# Technical Service Information

## FORD 4R70E/4R75E DTC P0715/P0717 OR ERRATIC SHIFTS

Figure 1

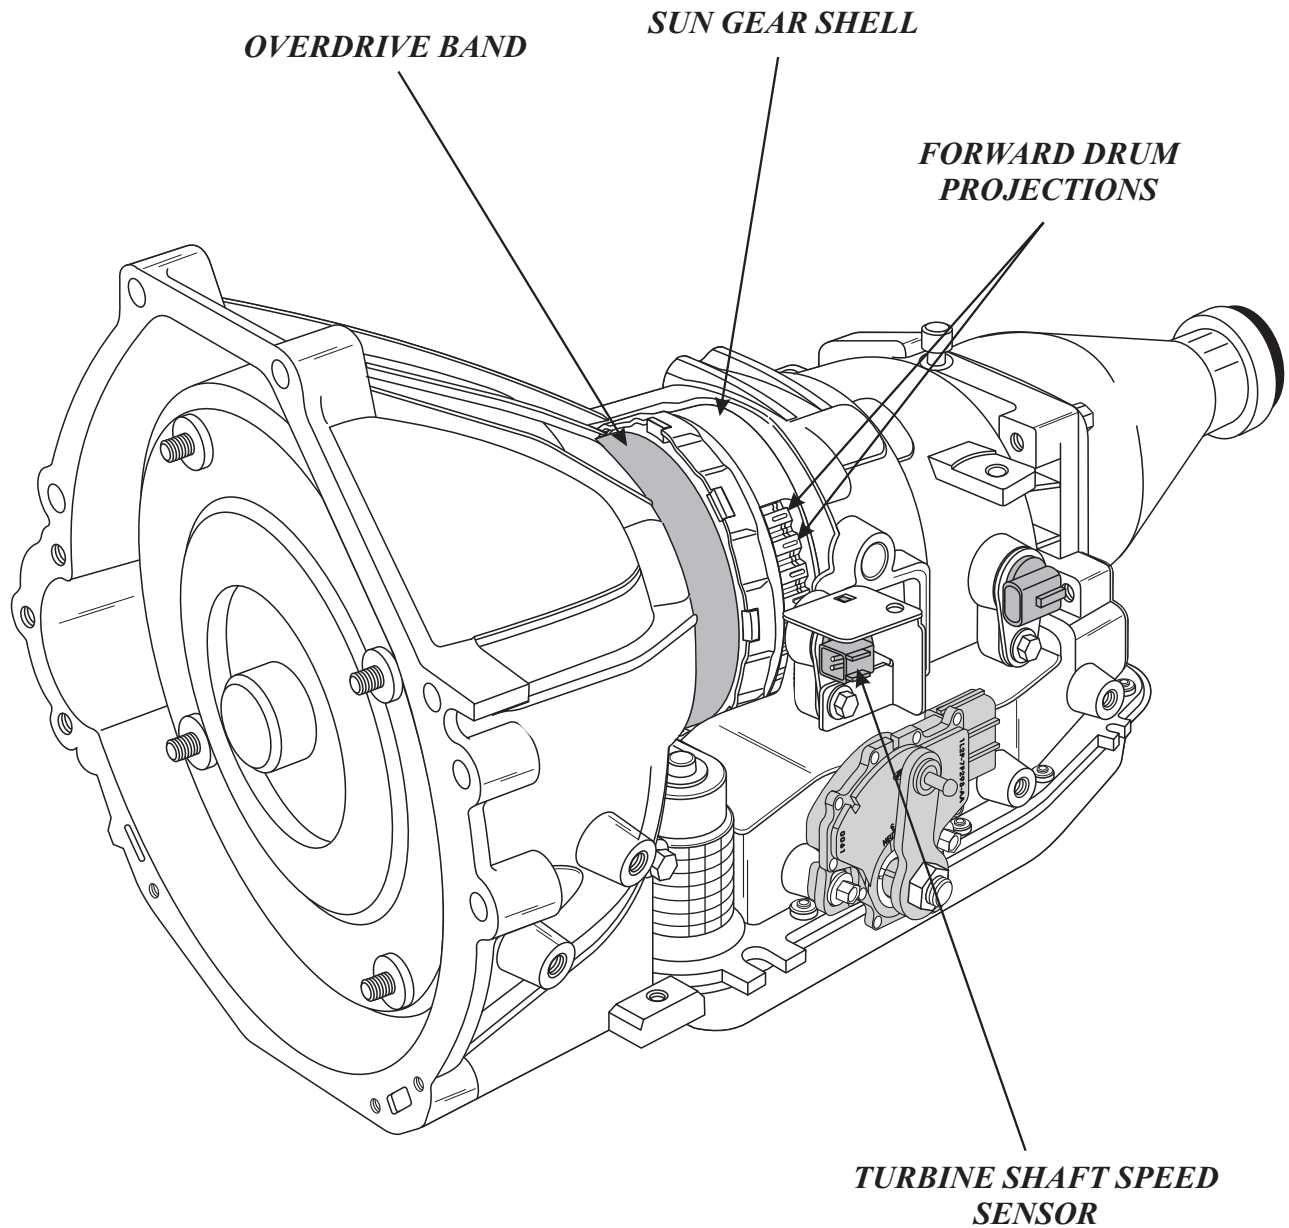
**CAUSE:** The cause may be, that the Forward Clutch Drum, as shown in Figure 2, or Sun gear Shell, as shown in Figure 3, were replaced with the previous design parts causing the Turbine Speed Sensor to return a false reading to the Powertrain Control Module. In the start of production for 2004 the Sun gear shell was made of a non-magnetic material to allow the new Turbine Shaft Speed Sensor to read the Forward Clutch Drum, calculating Turbine shaft speed for the PCM. At the same time the Forward Clutch Drum received a new stamping process, to provide 34 projections for the sensor to read from. See Figure 1 for a cross-sectional view.

Figure 2

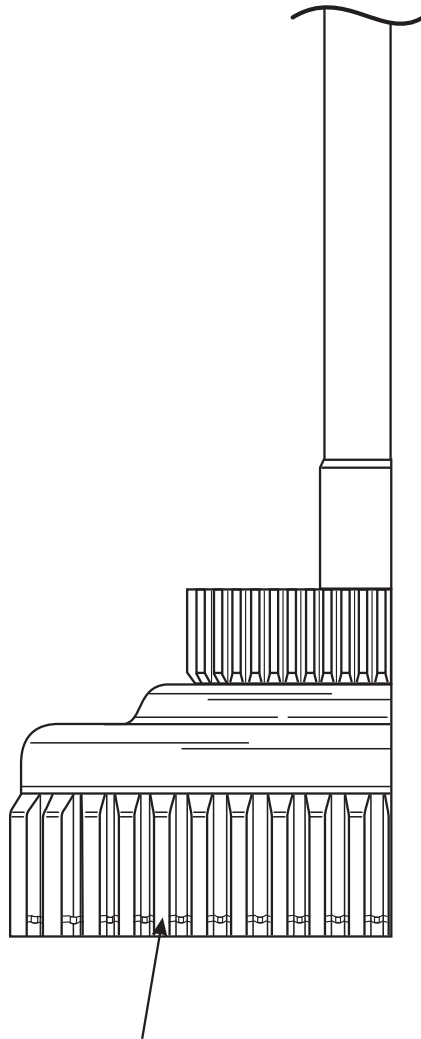
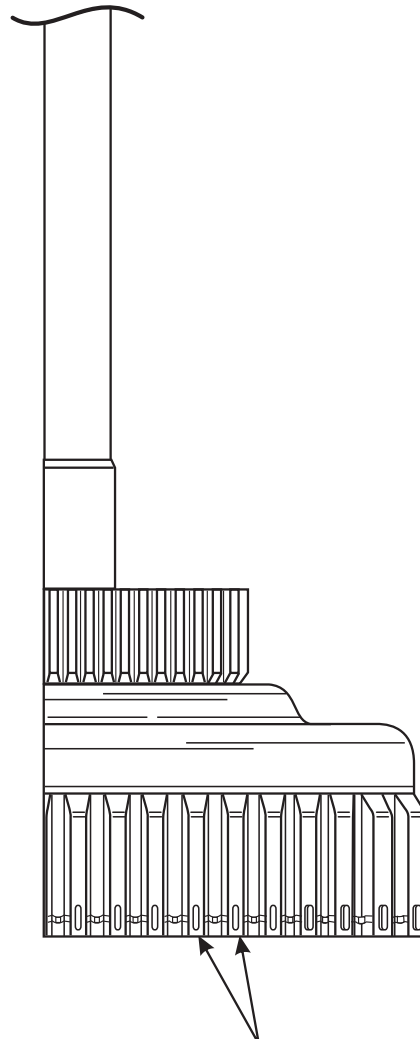
### *PREVIOUS DESIGN*

***NO PROJECTIONS***

### *NEW DESIGN*

***34 STAMPED PROJECTIONS  
ON THE OUTSIDE OF THE DRUM  
THAT THE ADDED TURBINE SENSOR  
READS FROM***

**CORRECTION:** Install the correct Forward Clutch Drum or Sun gear shell into the transmission and or replace the Turbine Shaft Speed Sensor as shown in Figure 4.

Figure 3

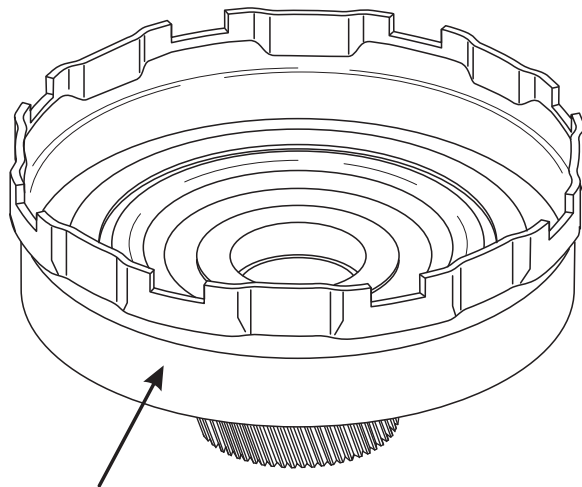
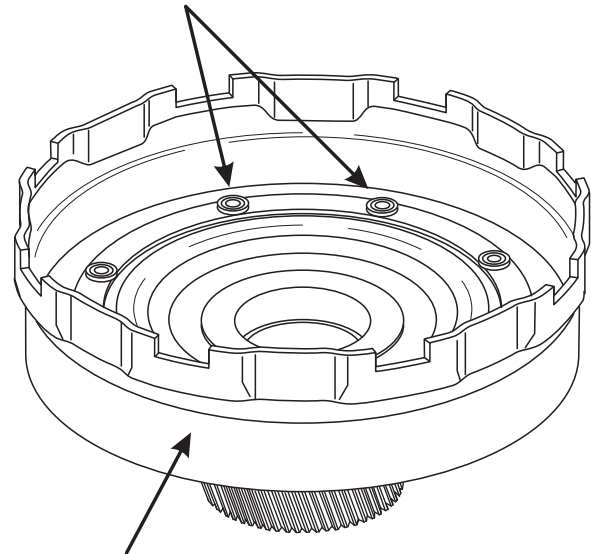
### *PREVIOUS DESIGN*

*MAGNETIC SHELL*

### *NEW DESIGN 4L3Z-7A019-BA*

*New Sun Shell Is Now Riveted  
To The Sun Gear And Hub*

*NON-MAGNETIC SHELL*

*NOTE: The New Sun Shell is made from  
a non-magnetic material so the Turbine sensor  
can read the Forward drum.*

*2005 models use the same type of Sun Shell  
and there are no rivets for identification.*

Figure 4

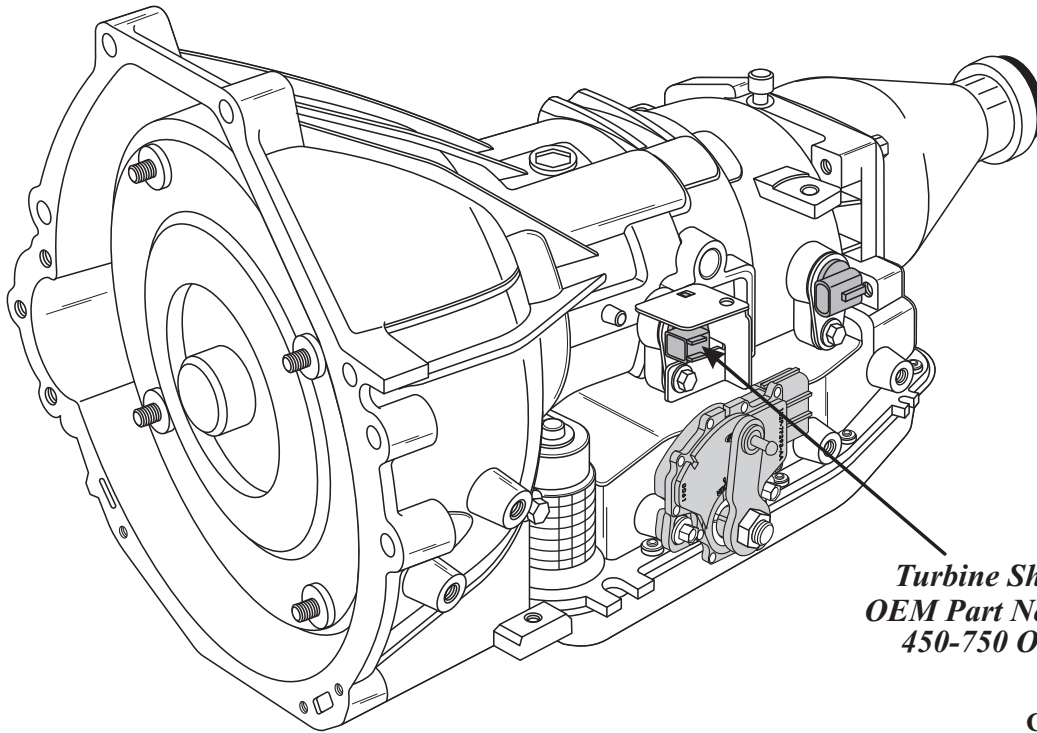
*Turbine Shaft Speed Sensor  
OEM Part No. 3L3Z-7M101-AA  
450-750 Ohms Resistance*
